ENFit male patient side connector vs. existing connectors

An analysis is prepared comparing the design and flow rate characteristics between the proposed ISO 80369-3 (ENFit) male patient side connector and the existing gastrostomy tube (G-tube) feeding connectors.

TEST #2
Gravity Flow Comparison

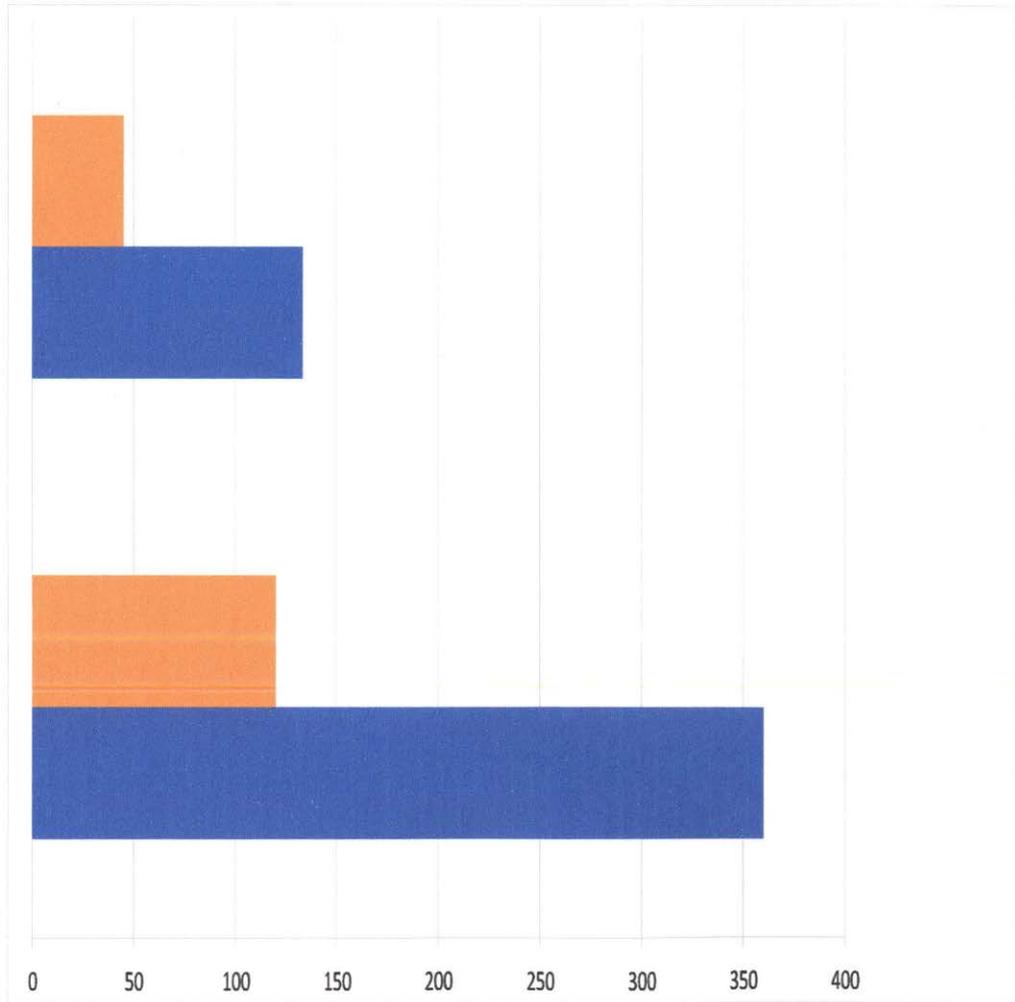
Test Results revealed that the time to empty a 60cc syringe using ISOSource 1.5 in a 20fr and 24fr PEG tube was **3x longer** when using an ENFit system versus existing connectors.

ENFit, therefore, is not essentially equivalent to existing connectors.

FIG. 1

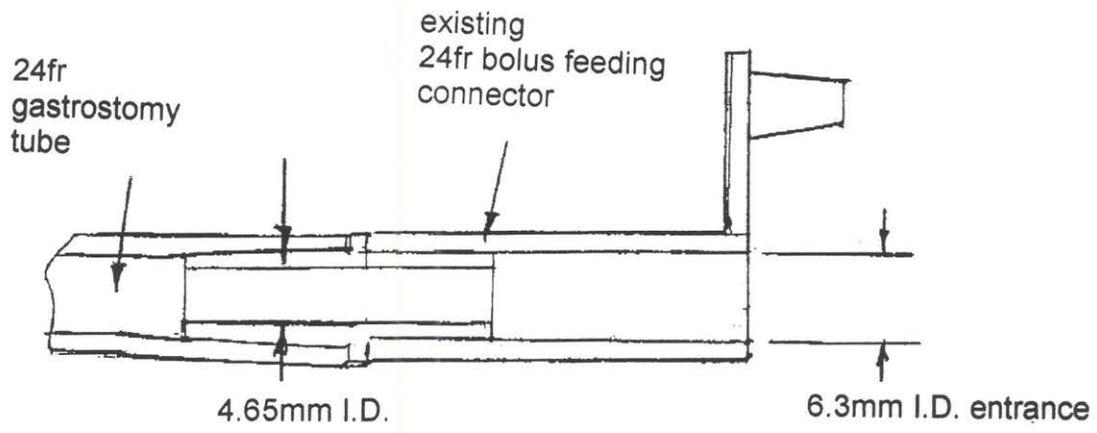
Fig. 1 on page 23 of this document is an internal flow volume drawing of an existing bolus feeding connector as part of a 24fr PEG tube (Cook Endoscopy BFA-24 as part of PEG placement kits).

As can be seen from Fig. 1, the existing connector has a large bore proximal entrance of about 6.3 mm, with a minimum internal diameter of 4.65 mm. The entire internal flow path is funnel shaped and smooth such that routine flushing/irrigation of the connector will keep the flow path clear of clogged debris.

FIG. 2

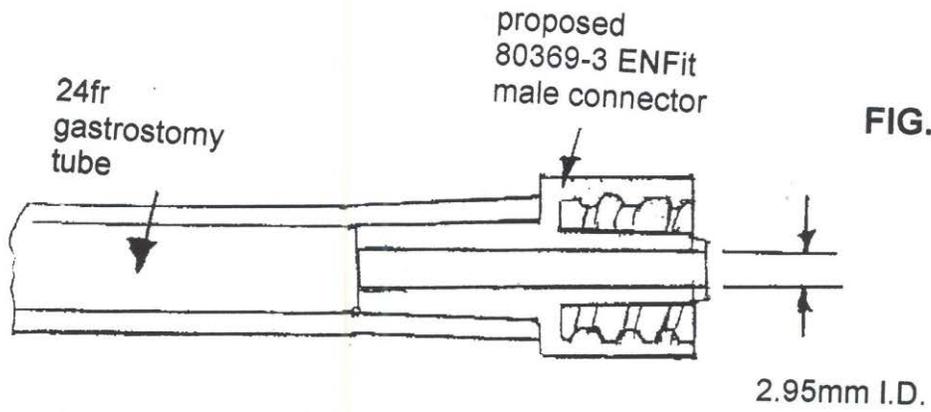
Fig. 2 on page 23 is an internal flow volume drawing of the proposed male ENFit connector as part of a 24fr PEG tube.

The proposed ENFit design which uses an internal female screw thread with a male stem and moat area. The ENFit connector has an inner diameter (I.D.) of only 2.95 mm, compared to 4.65 mm of the existing connector shown in Fig. 1.

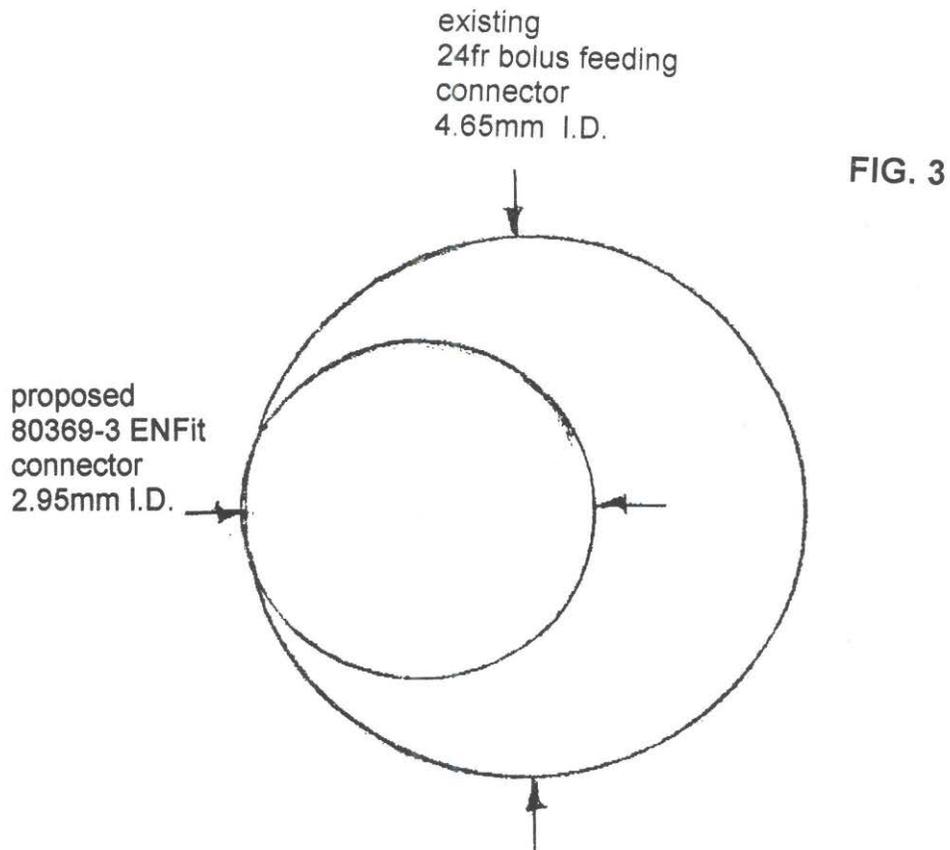
Fig. 3 on page 24 is an internal flow volume drawing comparing the 4.65 mm internal diameter of an existing 24fr bolus feeding connector (Cook Endoscopy BFA-24 as part of PEG placement kits) with the proposed 2.95 mm I.D. of the ENFit connector.

There is shown an enlarged 20 to 1 scaled volume flow path drawing comparing the existing 24fr bolus connector with the constricted ENFit connector.

Using this formula, the existing 24fr bolus connector has a volume flow value of 467.5 compared to the proposed ENFit volume flow value of only 75.7.

The ENFit connector has an 84% lower flow volume versus the existing 24fr bolus connector.

FIG. 4

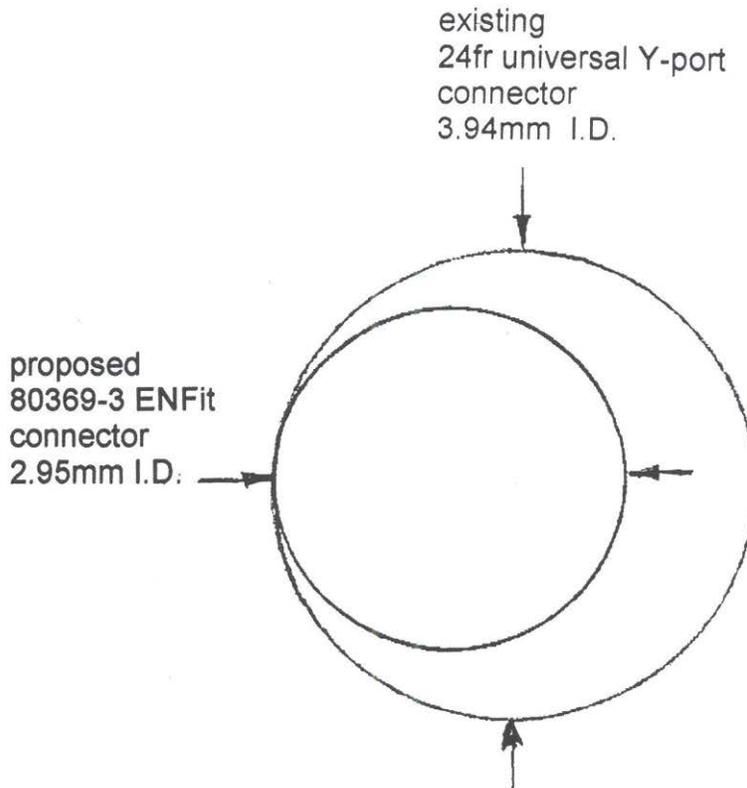
Fig. 4 on page 25 is an internal flow volume drawing comparing the 3.94 mm internal diameter of an existing universal/Y-port connector (Cook Endoscopy UFA-24) with the 2.95 mm I.D. of the ENFit connector.

Using the formula, the existing 24fr universal/Y-port connector has a volume flow value of 240.1 compared to the proposed ENFit volume flow value of only 75.7.

The ENFit connector has a 68.5% lower flow volume vs. the existing 24fr universal y-port connector.
